Technical Note

Project: Crown Street, Manchester
Client: Renaker
Ref: TS220375-N04-ISSUE03
Re: HSE Substantive response advice to LPA
Date: 8th September 2023
Author: H Parkes & D McMahon
Checked by: A. Foolkes

Table 1 – HSE comments and Tenos' responses for pgo-3550

Annex A1 – CS3 Proposed refuse store design alterations

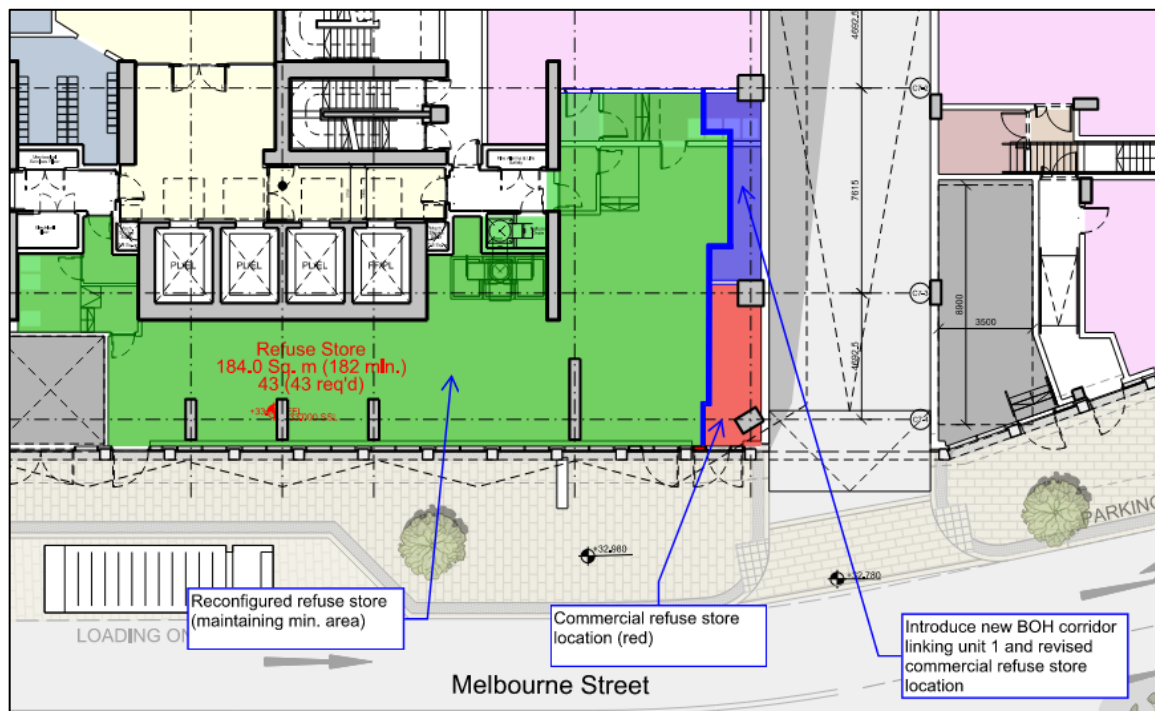
HSE Paragraph / Ref	HSE Comments	Tenos Comments
1.5 – 1.7	It is noted that commercial units C7-1, E1-1, 2, 3 and 4 and E2-2 link to the residential accommodation by way of the refuse holding stores and lobby to the fire-fighting stairs. Whilst it is noted that the stair to the ground floor commercial and the stair to the residential floors are separated by lobbies at ground floor, the adopted fire safety standard states: <i>“Any stair serving a dwelling within a mixed-use development should not communicate with any other occupancy, unless in accordance with a) or b)...a) In buildings having not more than three storeys above ground or access level (small buildings), common stairs that serve</i>	Thank you for your comment. The proposed amendments discussed below are shown in Figures A-1 to A-3. Unit C7-1 A fire-separated corridor and independent refuse store will be created for Unit C7-1 to remove the link between the commercial unit and residential accommodation. Unit E1-1, E1-2, E1-3 & E1-4 The commercial and residential refuse stores will be separated and accessed independently with no connection. An additional back-of-house corridor will be created to provide access from the commercial units to the refuse store.

In CS3, the design is to be amended to remove the connection between the residential and non-residential areas, as discussed in Table 1.
